ROSE STREET APARTMENTS
8124 RAINIER AVENUE SOUTH

DESIGN REVIEW
01/13/09
Project # 3008728

EDG RESPONSE:

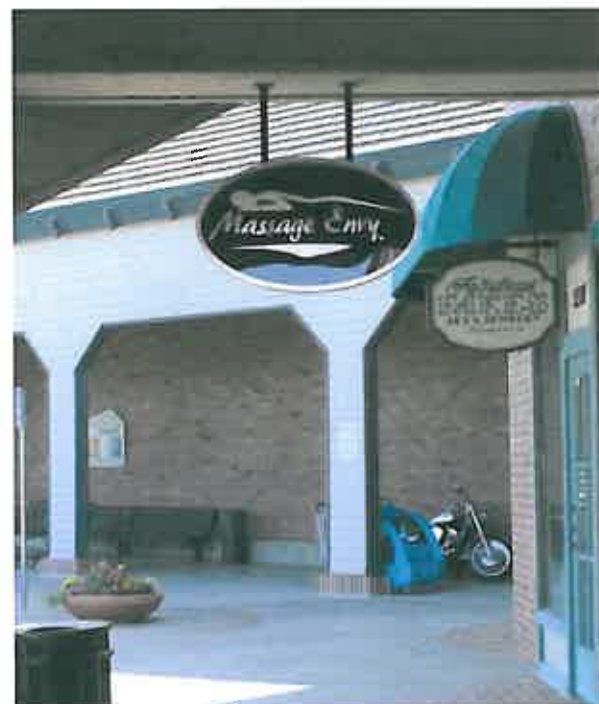
A-4 HUMAN ACTIVITY AND OPEN SPACE: Add more seating to the corner plaza area, the Rose Street Plaza, and the Play Area.

D-9 COMMERCIAL SIGNAGE: Please provide more detailed concept drawings for commercial signage.

RESPONSE: Benches have been added in several locations, including at the Corner Plaza, the Rose Street Plaza, and

RESPONSE: Images of the proposed signage types and styles have been included in the design review packet.

LIGHTING LEGEND:

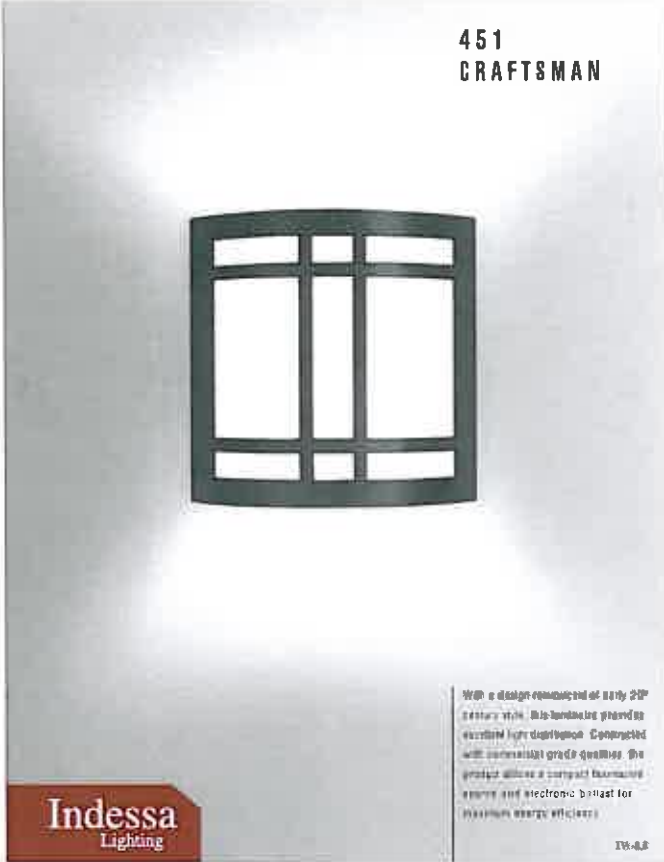
D-10 LIGHTING: Please provide a detailed lighting plan for exterior lighting including images of lighting fixtures.

A lighting plan has been included in the design review packet.

EAST (ALLEY) ELEVATION
SCALE: 1/16"=1'-0"

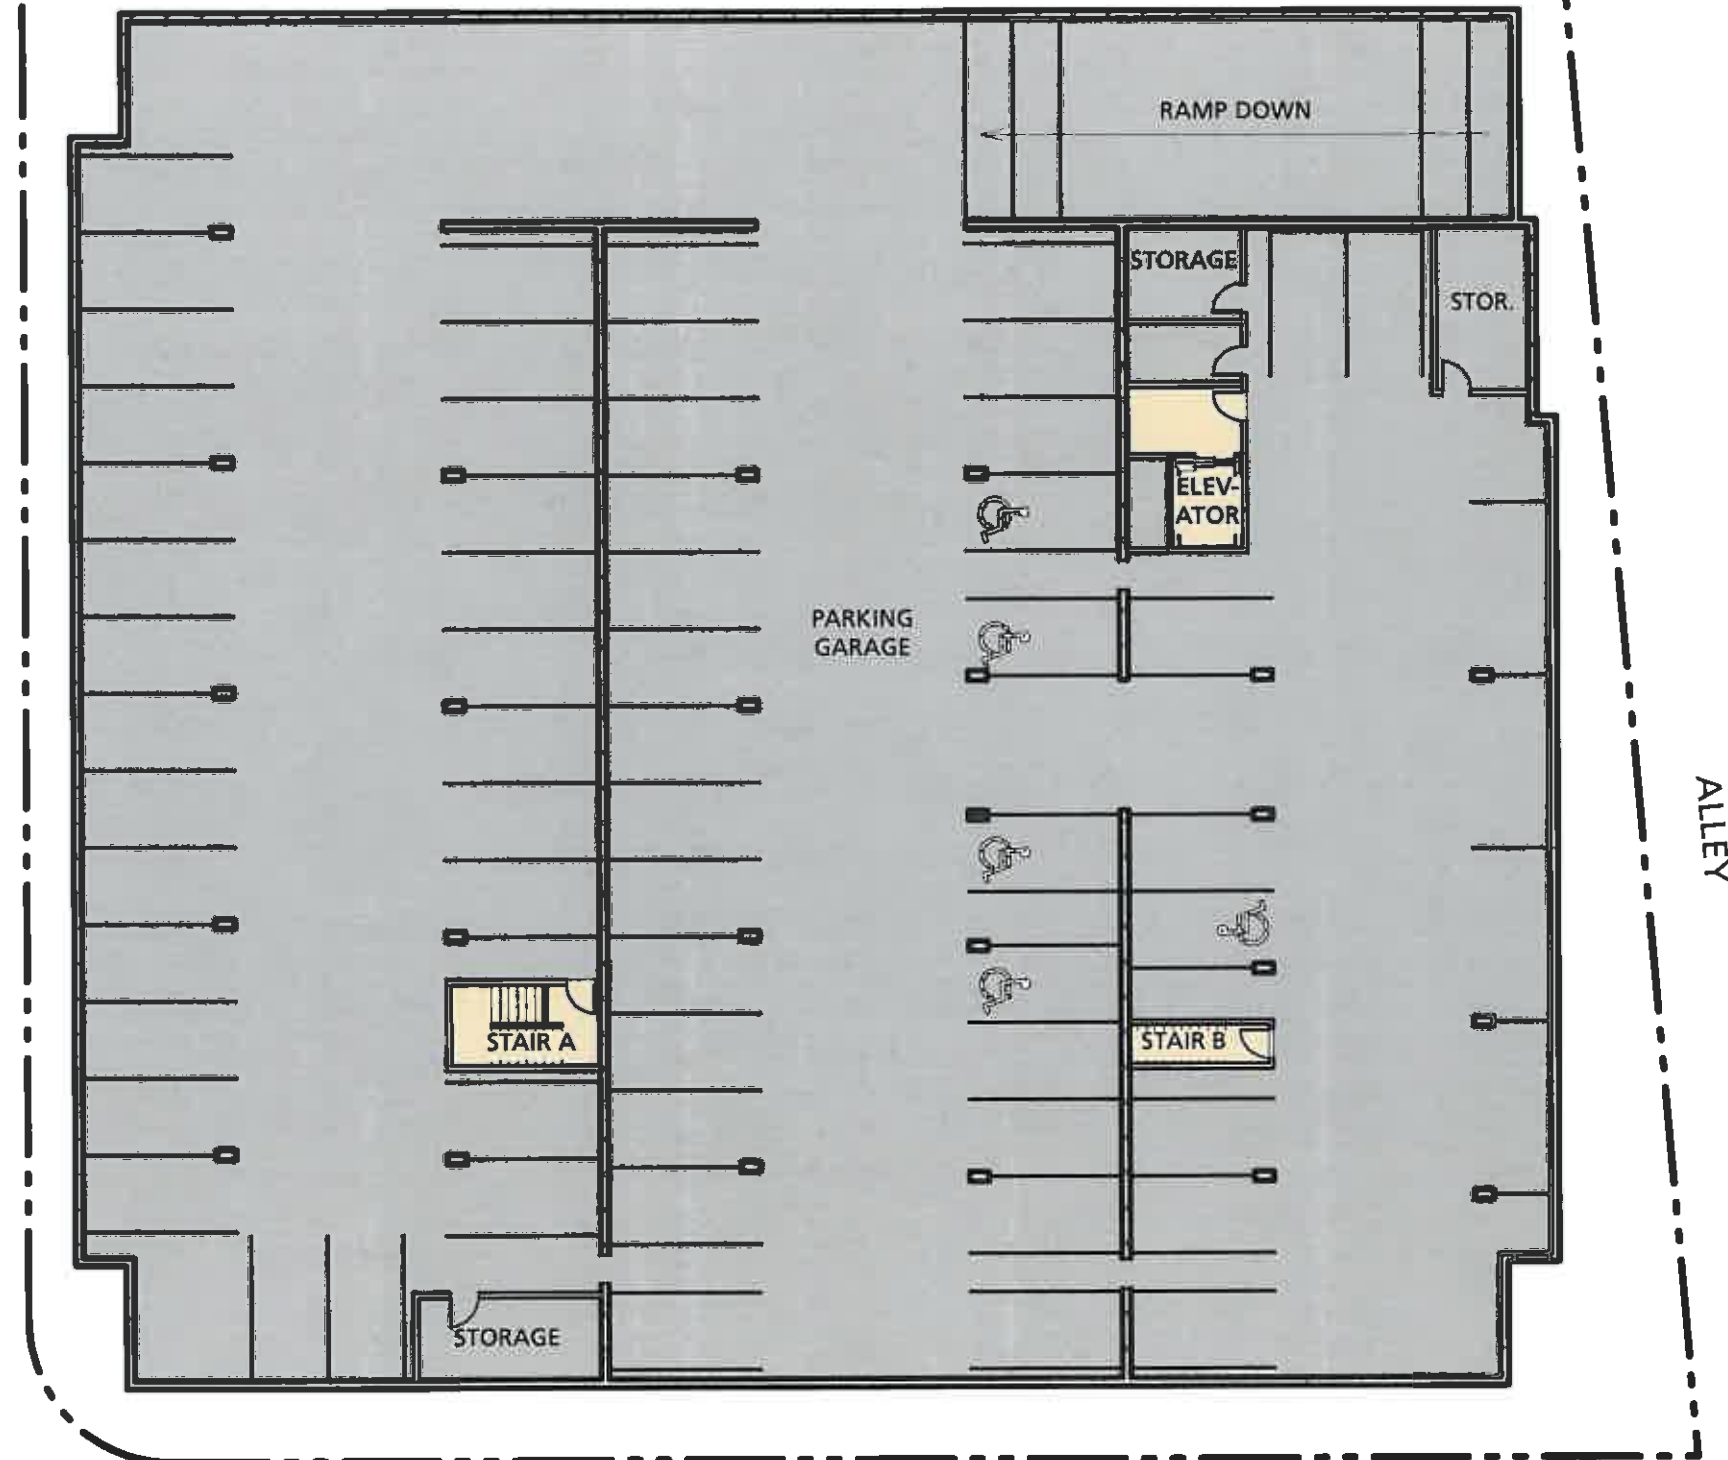
DEPARTURE #2: 23.47A.014 For a structure with more than one dwelling unit, a setback is required along any rear lot line that abuts a lot in a residential zone or that is across an alley from a lot in a residential zone, as follows:
Fifteen (15) feet for portions of structures above thirteen (13) feet in height to a maximum of forty (40) feet.

A portion of the building facing the alley extends 1'-11" into the upper level setback on the alley.

The building was moved on the site (both north and east) at the request of the Design Comission. The intrusion into the setback resulted from this.
SEE PAGE 16

RESIDENTIAL AREA
LESS THAN 10'-0"
FROM THE STREET
PROPERTY LINE:
155 SQ. FT. 6'-0"
MINIMUM SETBACK
FROM STREET
PROPERTY LINE

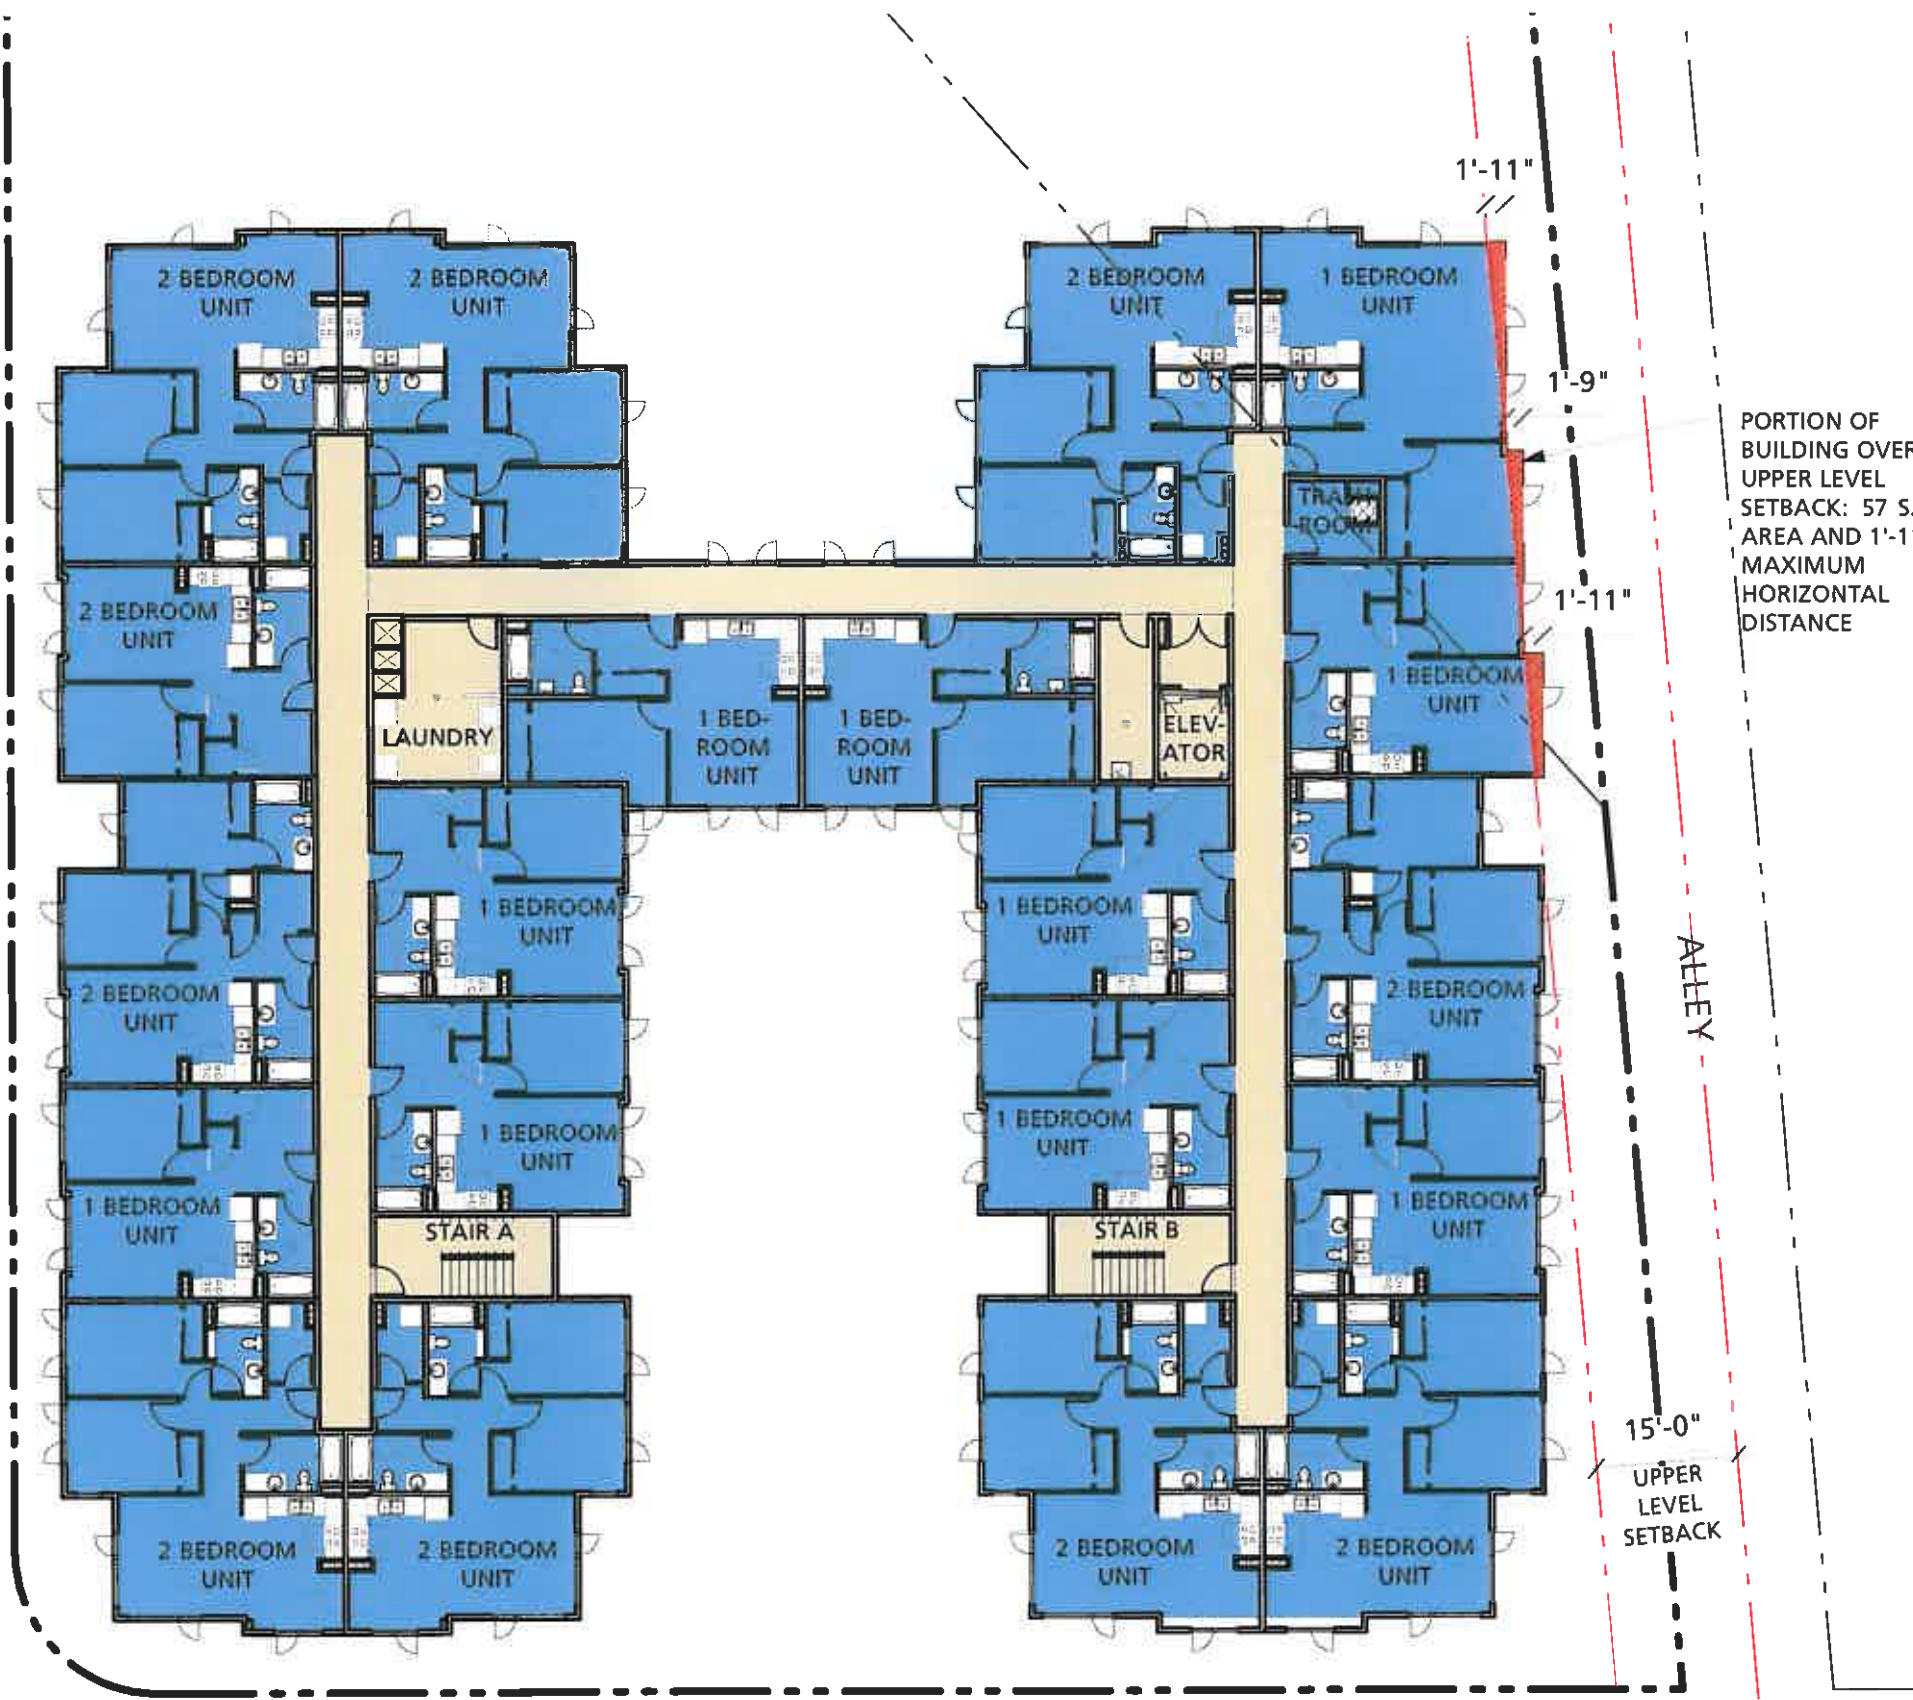
DEPARTURE #1: 23.47A.008.D.2 [For street facing residential uses] either the first floor of the structure at or above grade shall be at least four (4) feet above sidewalk grade or the street-level facade shall be set back at least ten (10) feet from the sidewalk.

A portion of the building on the first floor facing South Rose Street is 6'-0" from the property line.

Rose street is a minor street for an NC2-40 zone. Significant pedestrian traffic is not expected on Rose Street. Privacy in the units will be maintained by raising the height of window sills facing Rose Street, and by plantings.
SEE PAGE 15
